World Forum for Harmonization of Vehicle Regulations

Working Party on General Safety Provisions

Other business – Regulation No. 105 (ADR vehicles)**Proposal for amendments to Regulation No. 105****Submitted by the expert from the International Organization of Motor Vehicle Manufacturers ***

Annex 2, Model A, amend the approval mark and the explanatory text below the figure, to read:

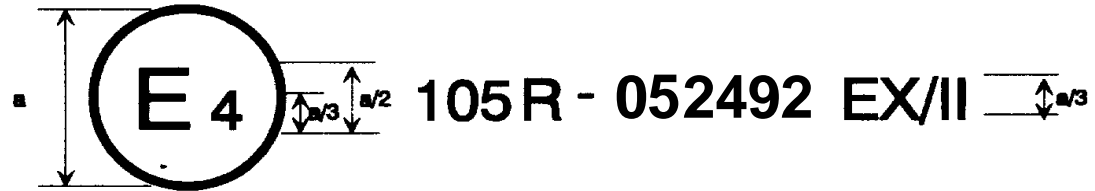
The above approval mark ... under the approval number ~~04~~ 052492 and ...requirements of Regulation No. 105, as amended by the ~~04~~ 05 series of amendments.”

Annex 2, Model B, amend the approval mark and the explanatory text below the figure, to read:

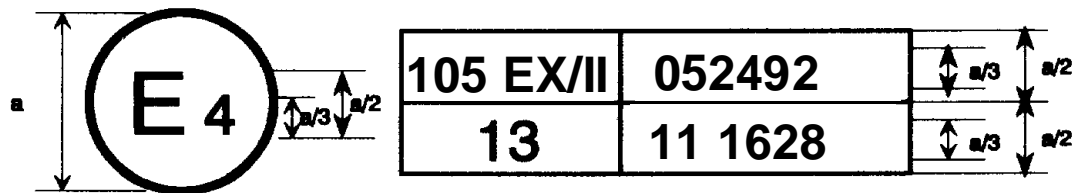
The above approval mark ... , Regulation No. 105, as amended by the ~~04~~ 05 series of amendments, while Regulation No. 13 already included the ~~09~~ 11 series of amendments.”
